NEWCASTLE CYCLEWAYS

Newcastle Inner City Bypass (Rankin Park to Jesmond)

EIS design December 2016

Unique Opportunity; Bi-directional parallel path, end to end:

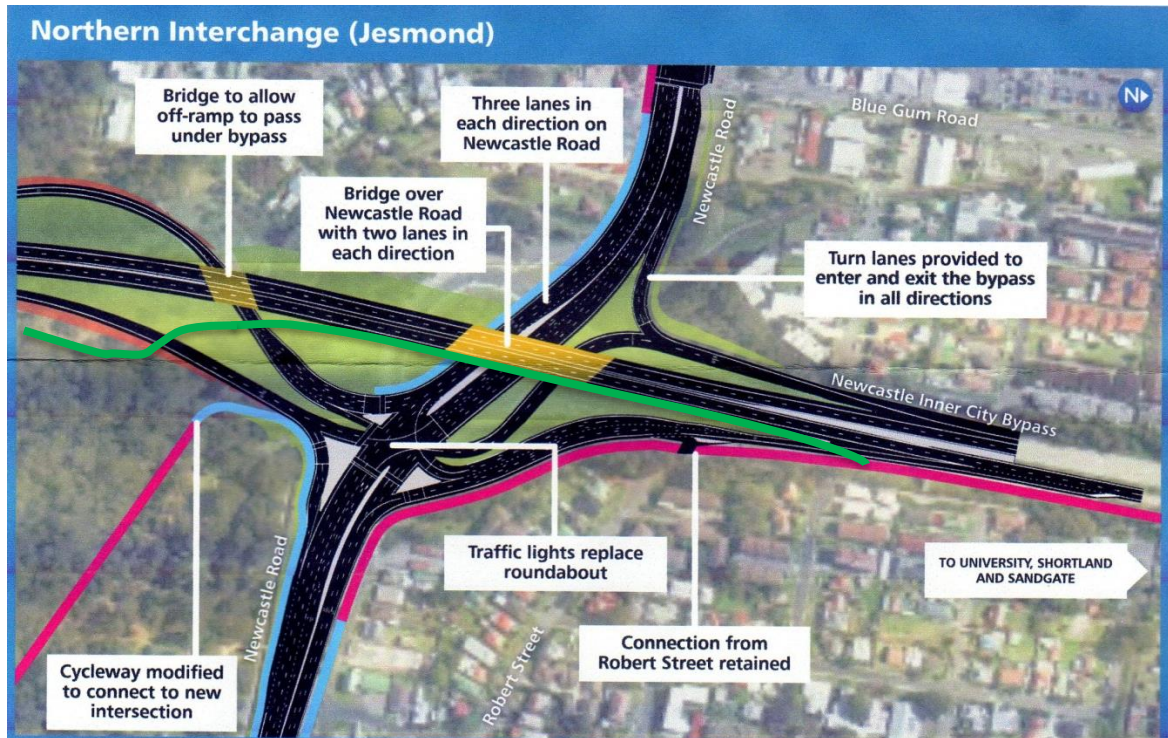
There is a once only ever opportunity in this project to provide an excellent high quality active transport link from the University, connecting with the John Hunter Hospital precinct, and then through to the Blackbutt reserve, at very little additional cost. There will never be another opportunity to build this shared path at anywhere near the cost that this would add to this project if done at the time of the bypass construction. Most Futurists predict a future with a stronger emphasis on active travel therefore this is an opportunity that cannot be missed.

This protected shared path would link in the north with the existing “University” path in the vicinity of the existing east-west shared path bridge as shown below. A new bridge in this vicinity has the height to clear the existing off ramps, and links in well with users from both sides of the existing bypass section. The shared path would then bridge Newcastle road with the bypass structure. A path of this design allows the fastest and most convenient connection for active travel between the University and the Hospital.

Proposed northern route of bi-directional shared path, end to end

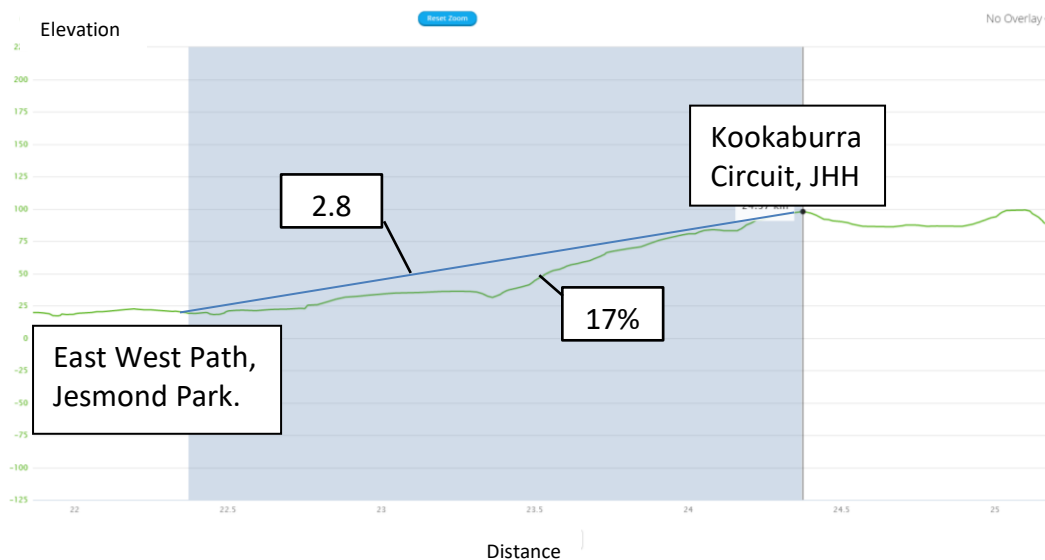
South of Newcastle Road this bi-directional shared path should keep away from the bypass as far as reasonably possible considering the best gradient to achieve the highest usage, the best and cheapest engineering, and the best amenity for the active transport users.

Again the emphasis is that there will never be another opportunity to build this path.

In the southern interchange this path would reasonably connect with the signalised crossings at McCaffrey Drive.

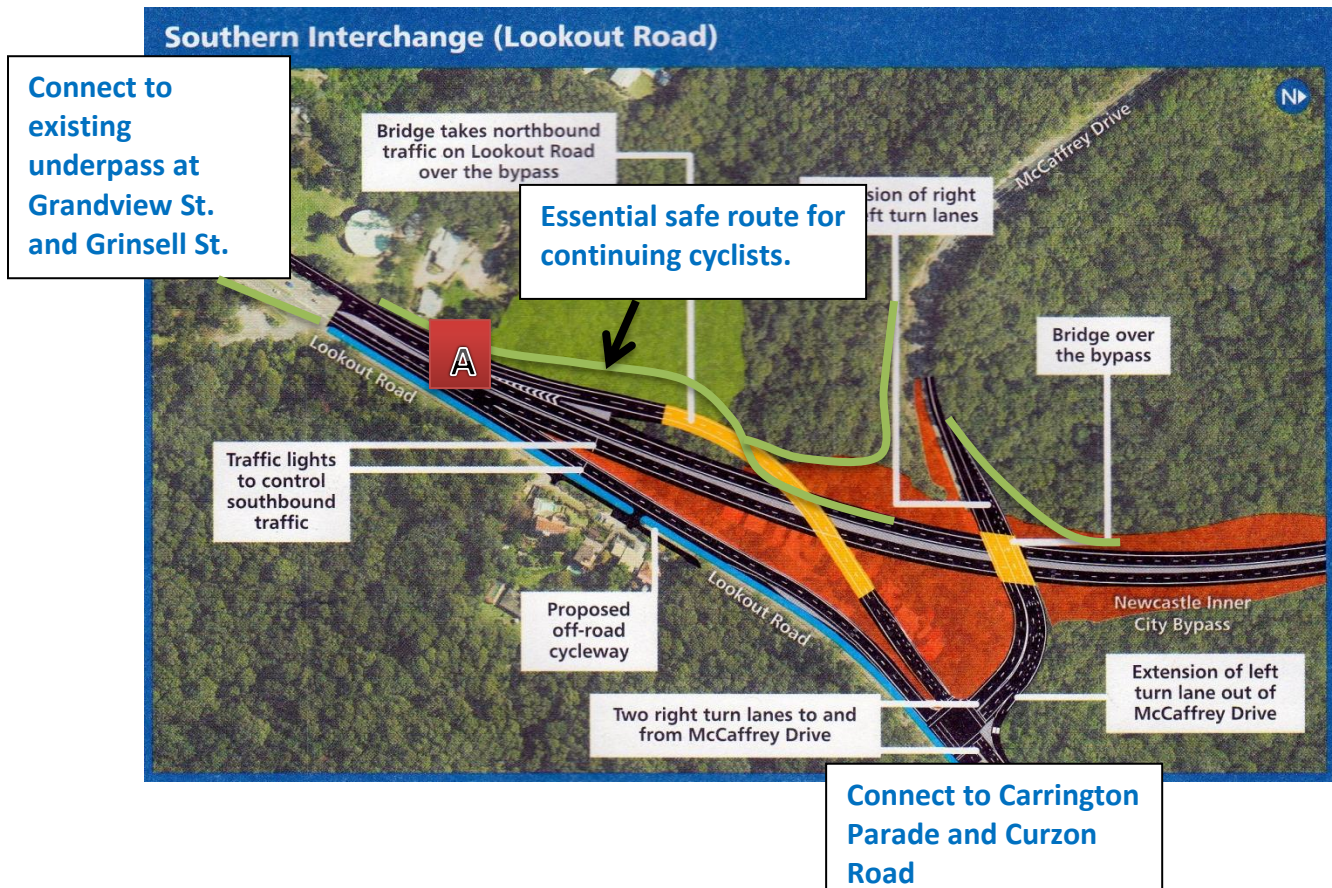
The EIS claims this path will join up with the existing underpass of Lookout Road near the intersection of Grandview Parade, via the carpark of Blackbutt Reserve. The gates to this car park are locked overnight, prohibiting free bicycle access. The grade from the car park down to the eastern end of the would need to be reduced for safe approaches, and the existing track is not sealed. There is a lot of work to resolve these problems before the claim can be accepted that the proposed Lookout Road Path links with this underpass.

Ideally this path should continue to the signalised intersection of Carnley Avenue thus allowing connection with the existing Grinsel Street cycle route/path.

Point A in the diagram above; where the Lookout Road traffic has two lanes to continue north along to the existing lookout road presents a serious safety hazard to people riding north along the proposed bypass, i.e. to the University. This requires them to change across 2 lanes of full speed traffic. This is similar to the situation at Hexham where north bound traffic veers left to take the Hexham Bridge. Cyclists continuing north have the option of a slip lane west of this bridge bringing them to the Oak Hungry Jacks signalised intersection. Using this precedent a similar resolution is also proposed here for Lookout Road, referred to as the Essential safe route for continuing cyclists above

NCM acknowledges that during the December special briefing the RMS RP2J design team were able to show conceptual work on a route much as indicated.

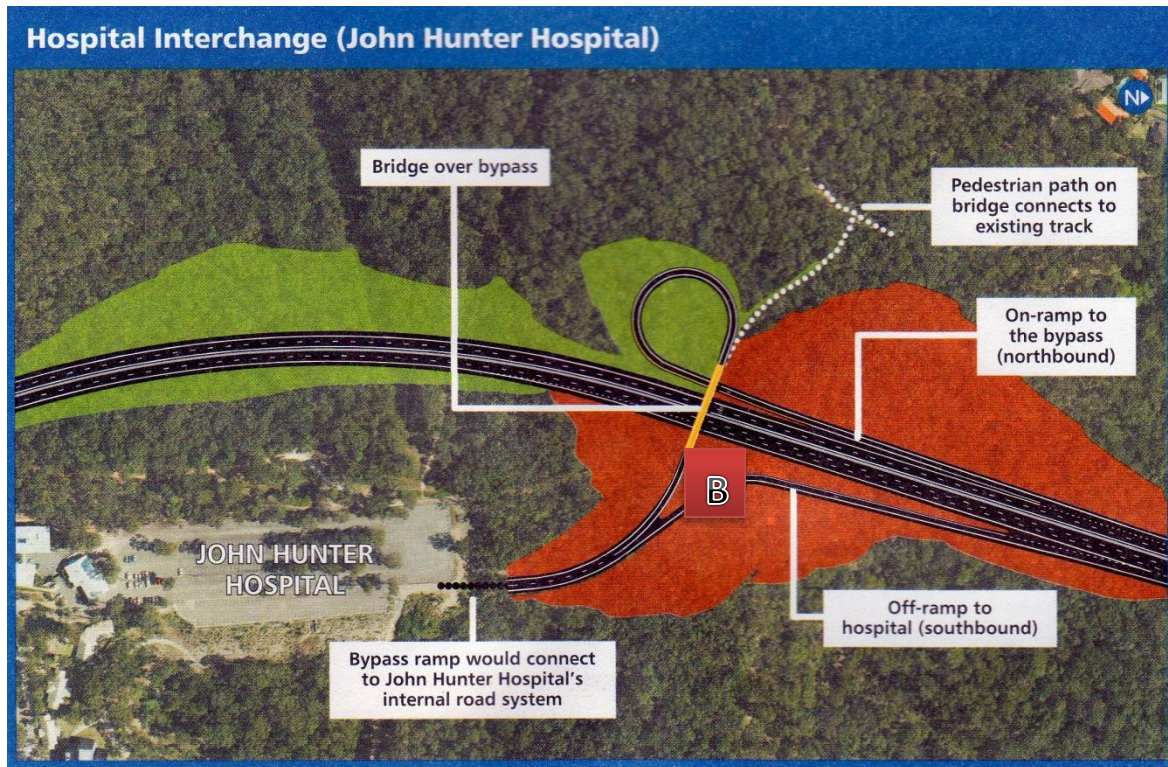
Please also consider the provision of a small and direct path off the above Essential safe route for cyclist directly onto the re-aligned McCaffrey Drive, avoiding the need to continue to the proposed lighted intersection.

During the December special briefing, the need to bring cyclists safely off the bypass, riding south, and onto Lookout road was also raised. The problem here is the cyclists approaching this intersection are coming out of a steep climb with a slow pace, and may take some time to move across to the left of Lookout Road. A refuge in the tapering island was suggested. A ramp should also be provided to ensure cyclists can get off Lookout Road, and onto the shared path.

Figure 5-8 (p117 EIS) raises further concerns about this design.

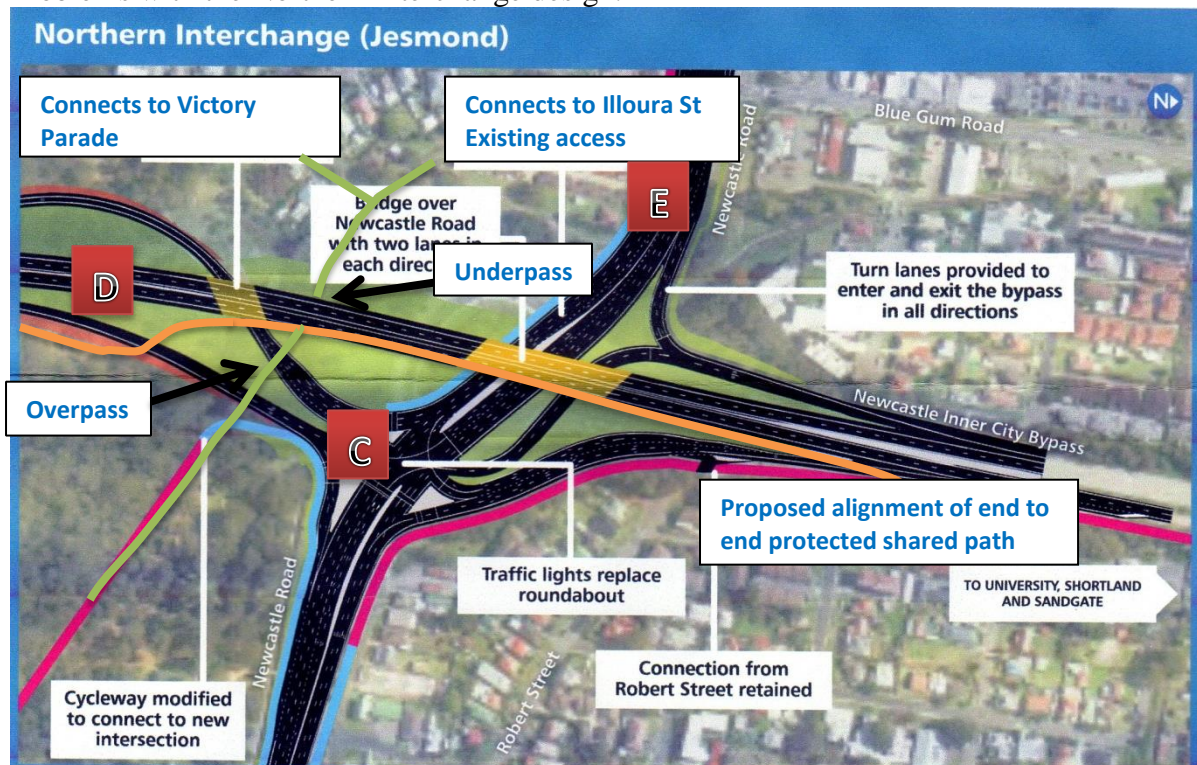
If this is a genuine shared path there should be protection between the traffic lane and the shared path. 2.5 m is not wide enough for a fire truck in an emergency situation.
